CABEZON COMMUNITIES

DRAINAGE IMPLEMENTATION

Addendum 1 Attached
1-21-05

**Re: Cabezon Communities Drainage Implementation Plan -
Amendment 1**

CABEZON COMMUNITIES
DEVELOPMENT - DRAINAGE
IMPLEMENTATION PLAN
FIGURE 2 - OVERALL
DRAINAGE SYSTEM

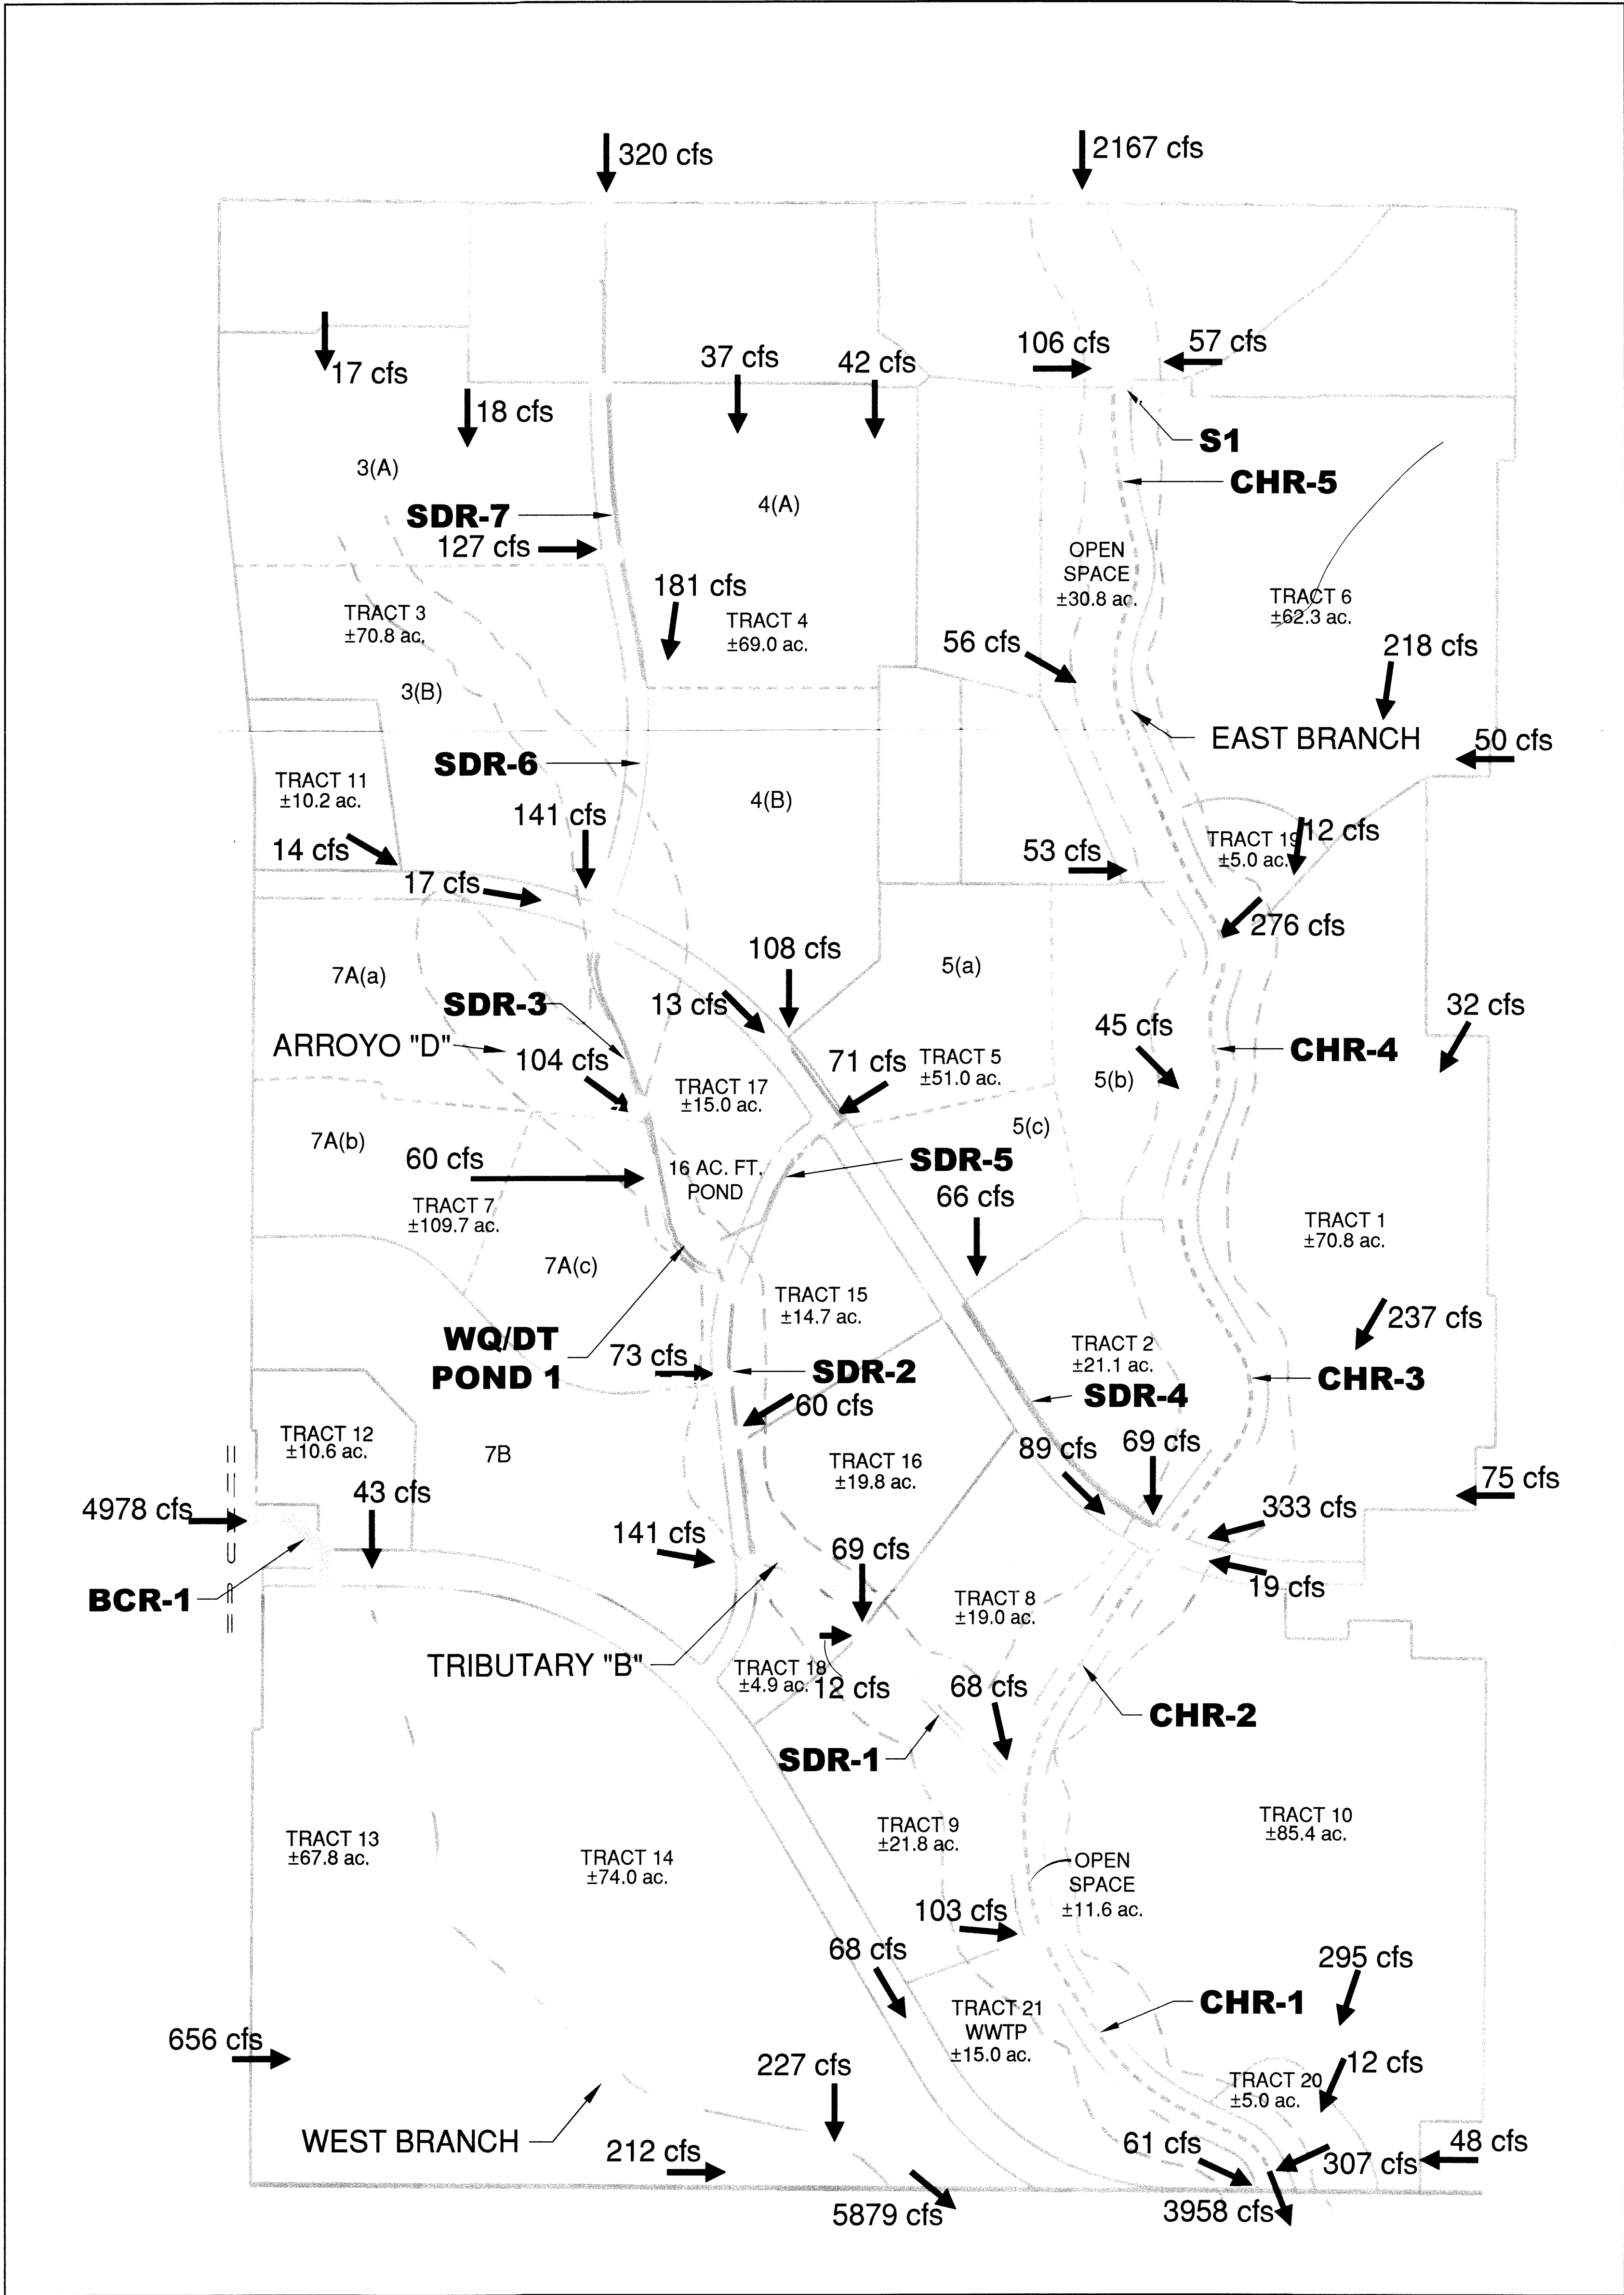
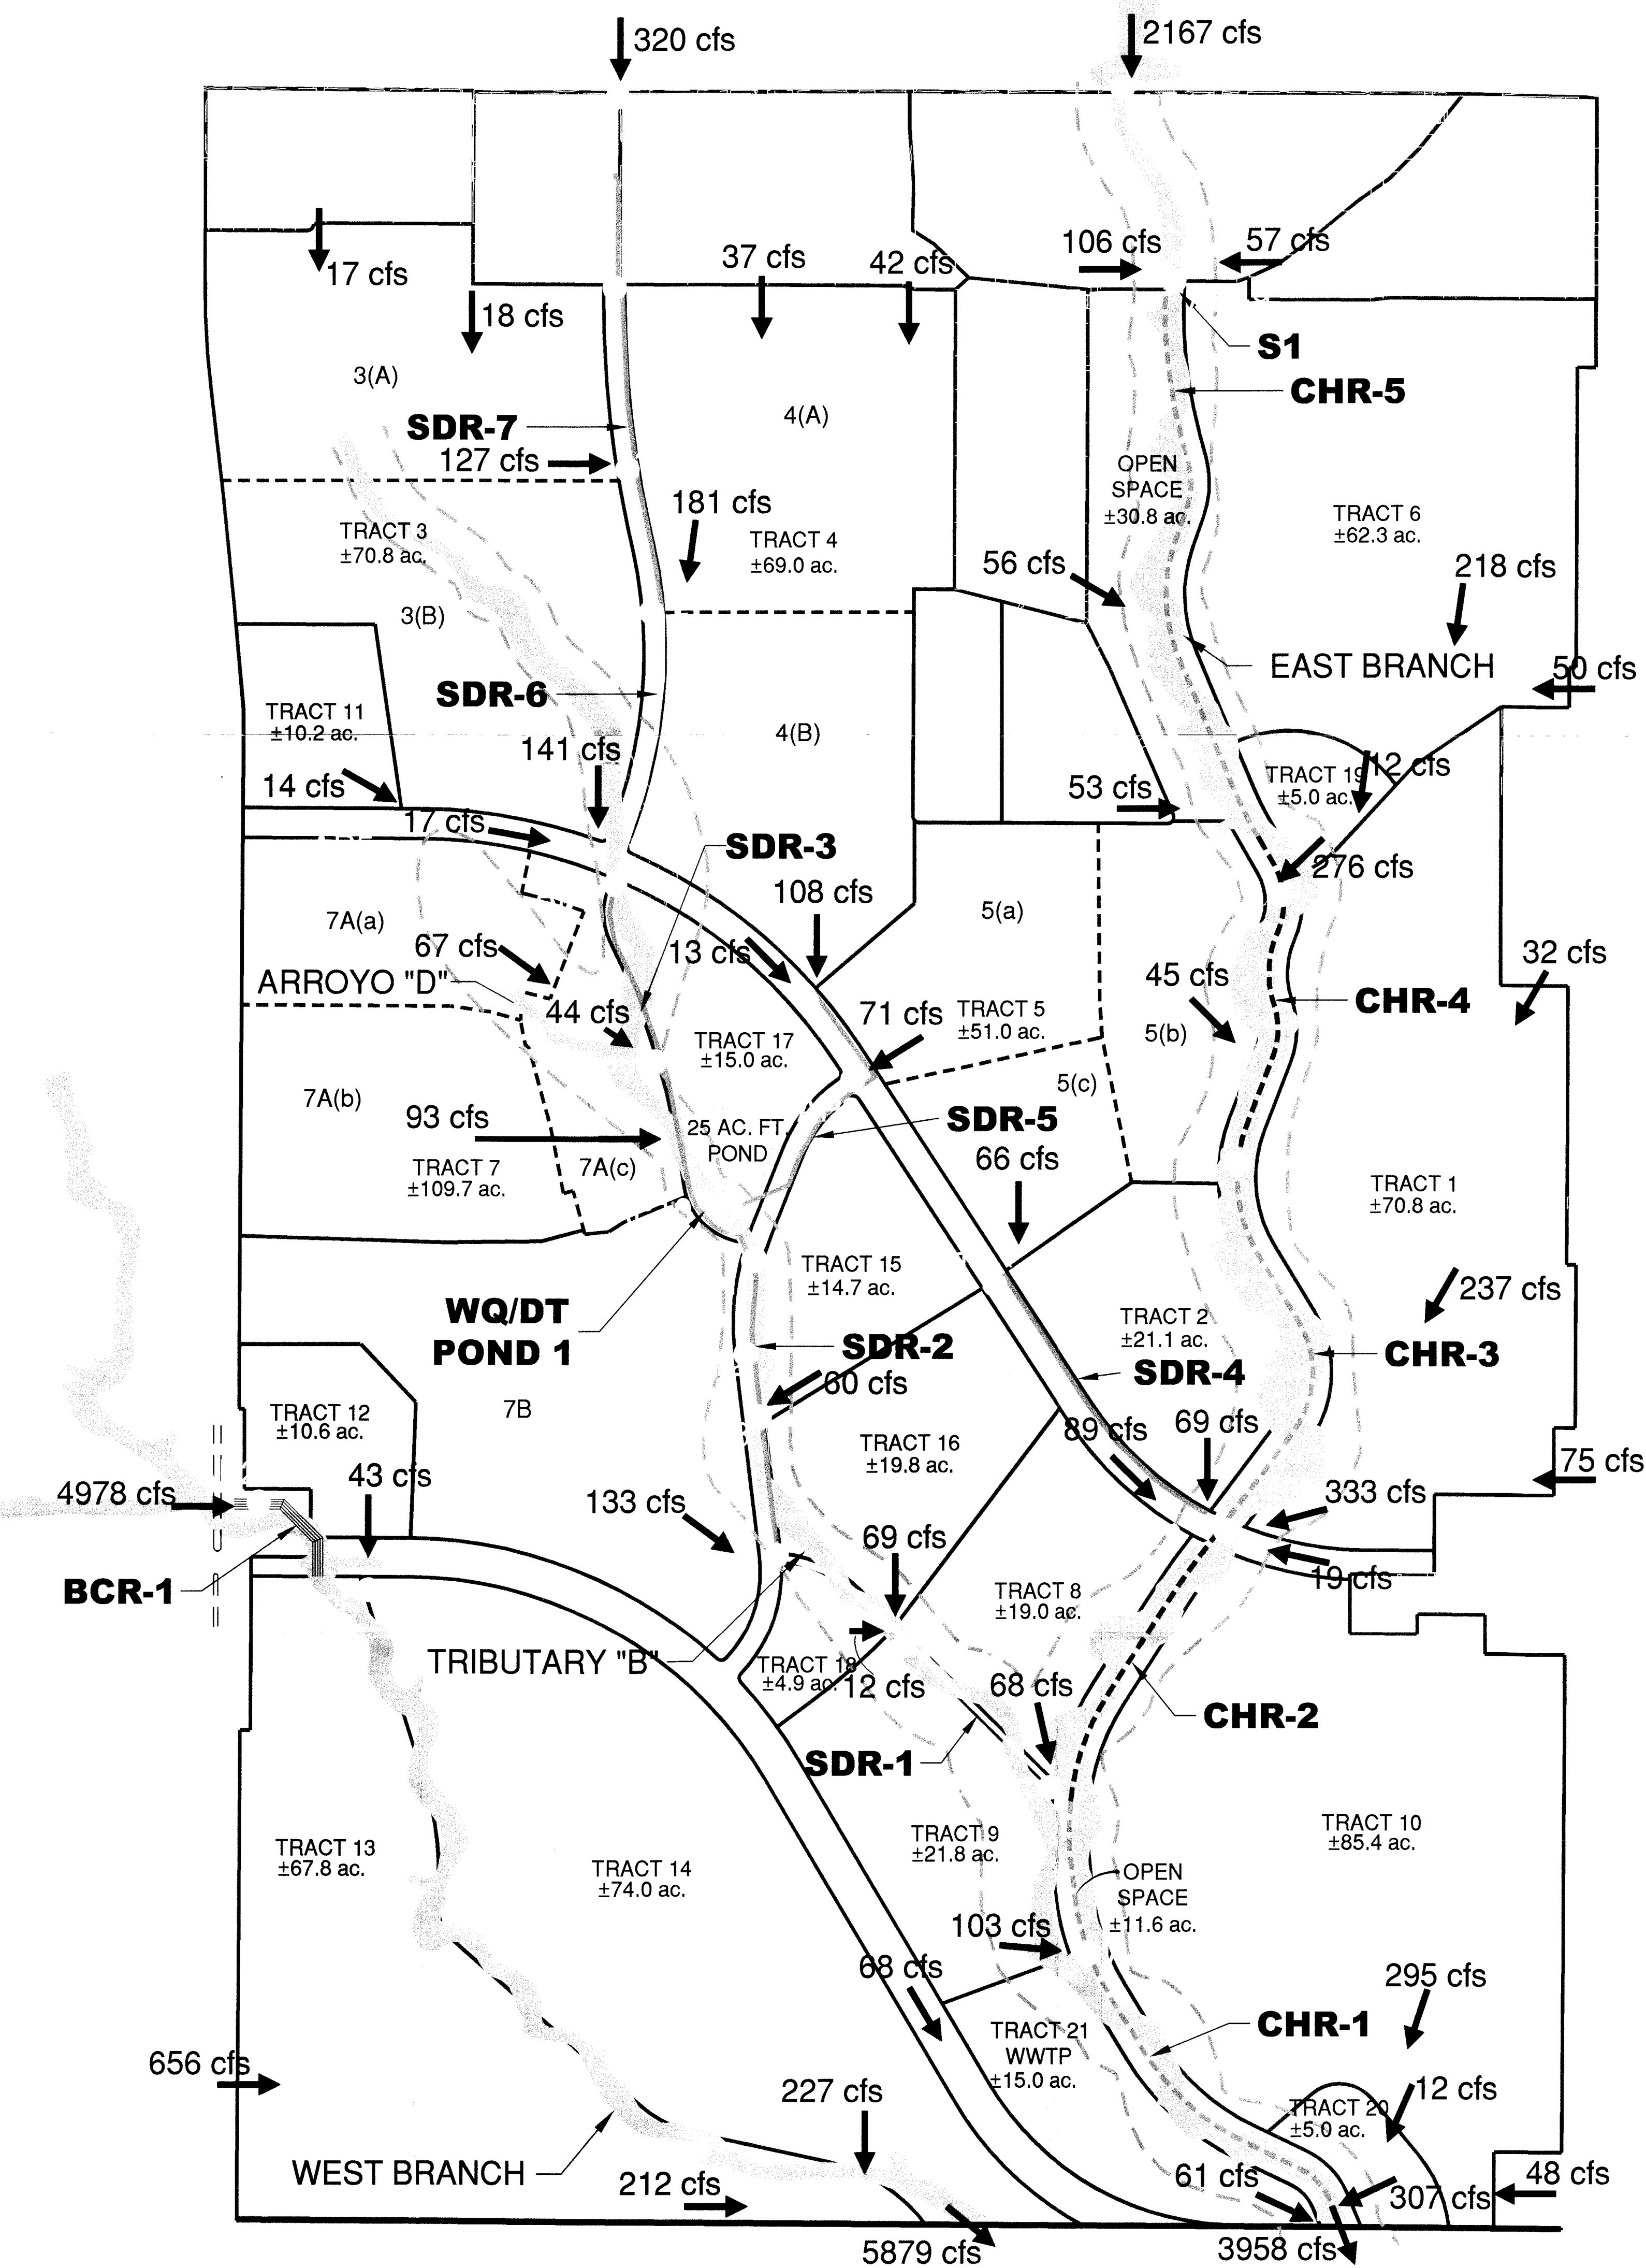
Attached is the revised Figure #2 for the Cabezón Communities Drainage Implementation Plan. As we discussed, a revision of this exhibit is due to a slight change in the internal drainage boundaries of Tract 7, identified on the Figure as drainage sub-basins 7A(a), 7A(b), 7A(c), and 7B and the final design of the drainage system for the subdivision located in Tract 7. The net result is a slight increase to the flows being introduced to Pond-1, and a slight reduction in flows in the storm drain system downstream of Pond-1. Changed values are shown in the following tables:

Analysis Point	Approved Flow (CFS)	Revised Flow (CFS)	Variance (CFS)
AP7	827	795	-32
AP8	120	120	NC
AP9	188	188	NC
AP10	1100	1132	+32
AP11	497	475	-22
AP12	502	475	-27
AP13	535	478	-57
AP14	631	550	-81

TRACT	Approved Allowable Flow (CFS)	Revised Allowable Flow (CFS)	Variance (CFS)
7A (TOTAL)	237	204	-33
7A(a)	104	67	-37
7A(b)	60	93	+33
7A(c)	73	44	-29
7B	141	133	-8

The additional flow to Pond-1 does not exceed the 25 AF volume originally approved and therefore requires no change. The above changes will be incorporated into the Cabezon Phase 2 DMP. With this letter and revised Figure #2, we request your approval for these revisions to the Cabezon Drainage Implementation Plan. If you have any questions please contact me or Mario Juarez-Infante. Your consideration of our request is appreciated.

NOTE: REVISED
7/20/04 TO REFLECT
UPDATED
SUBDIVISION
BOUNDARIES
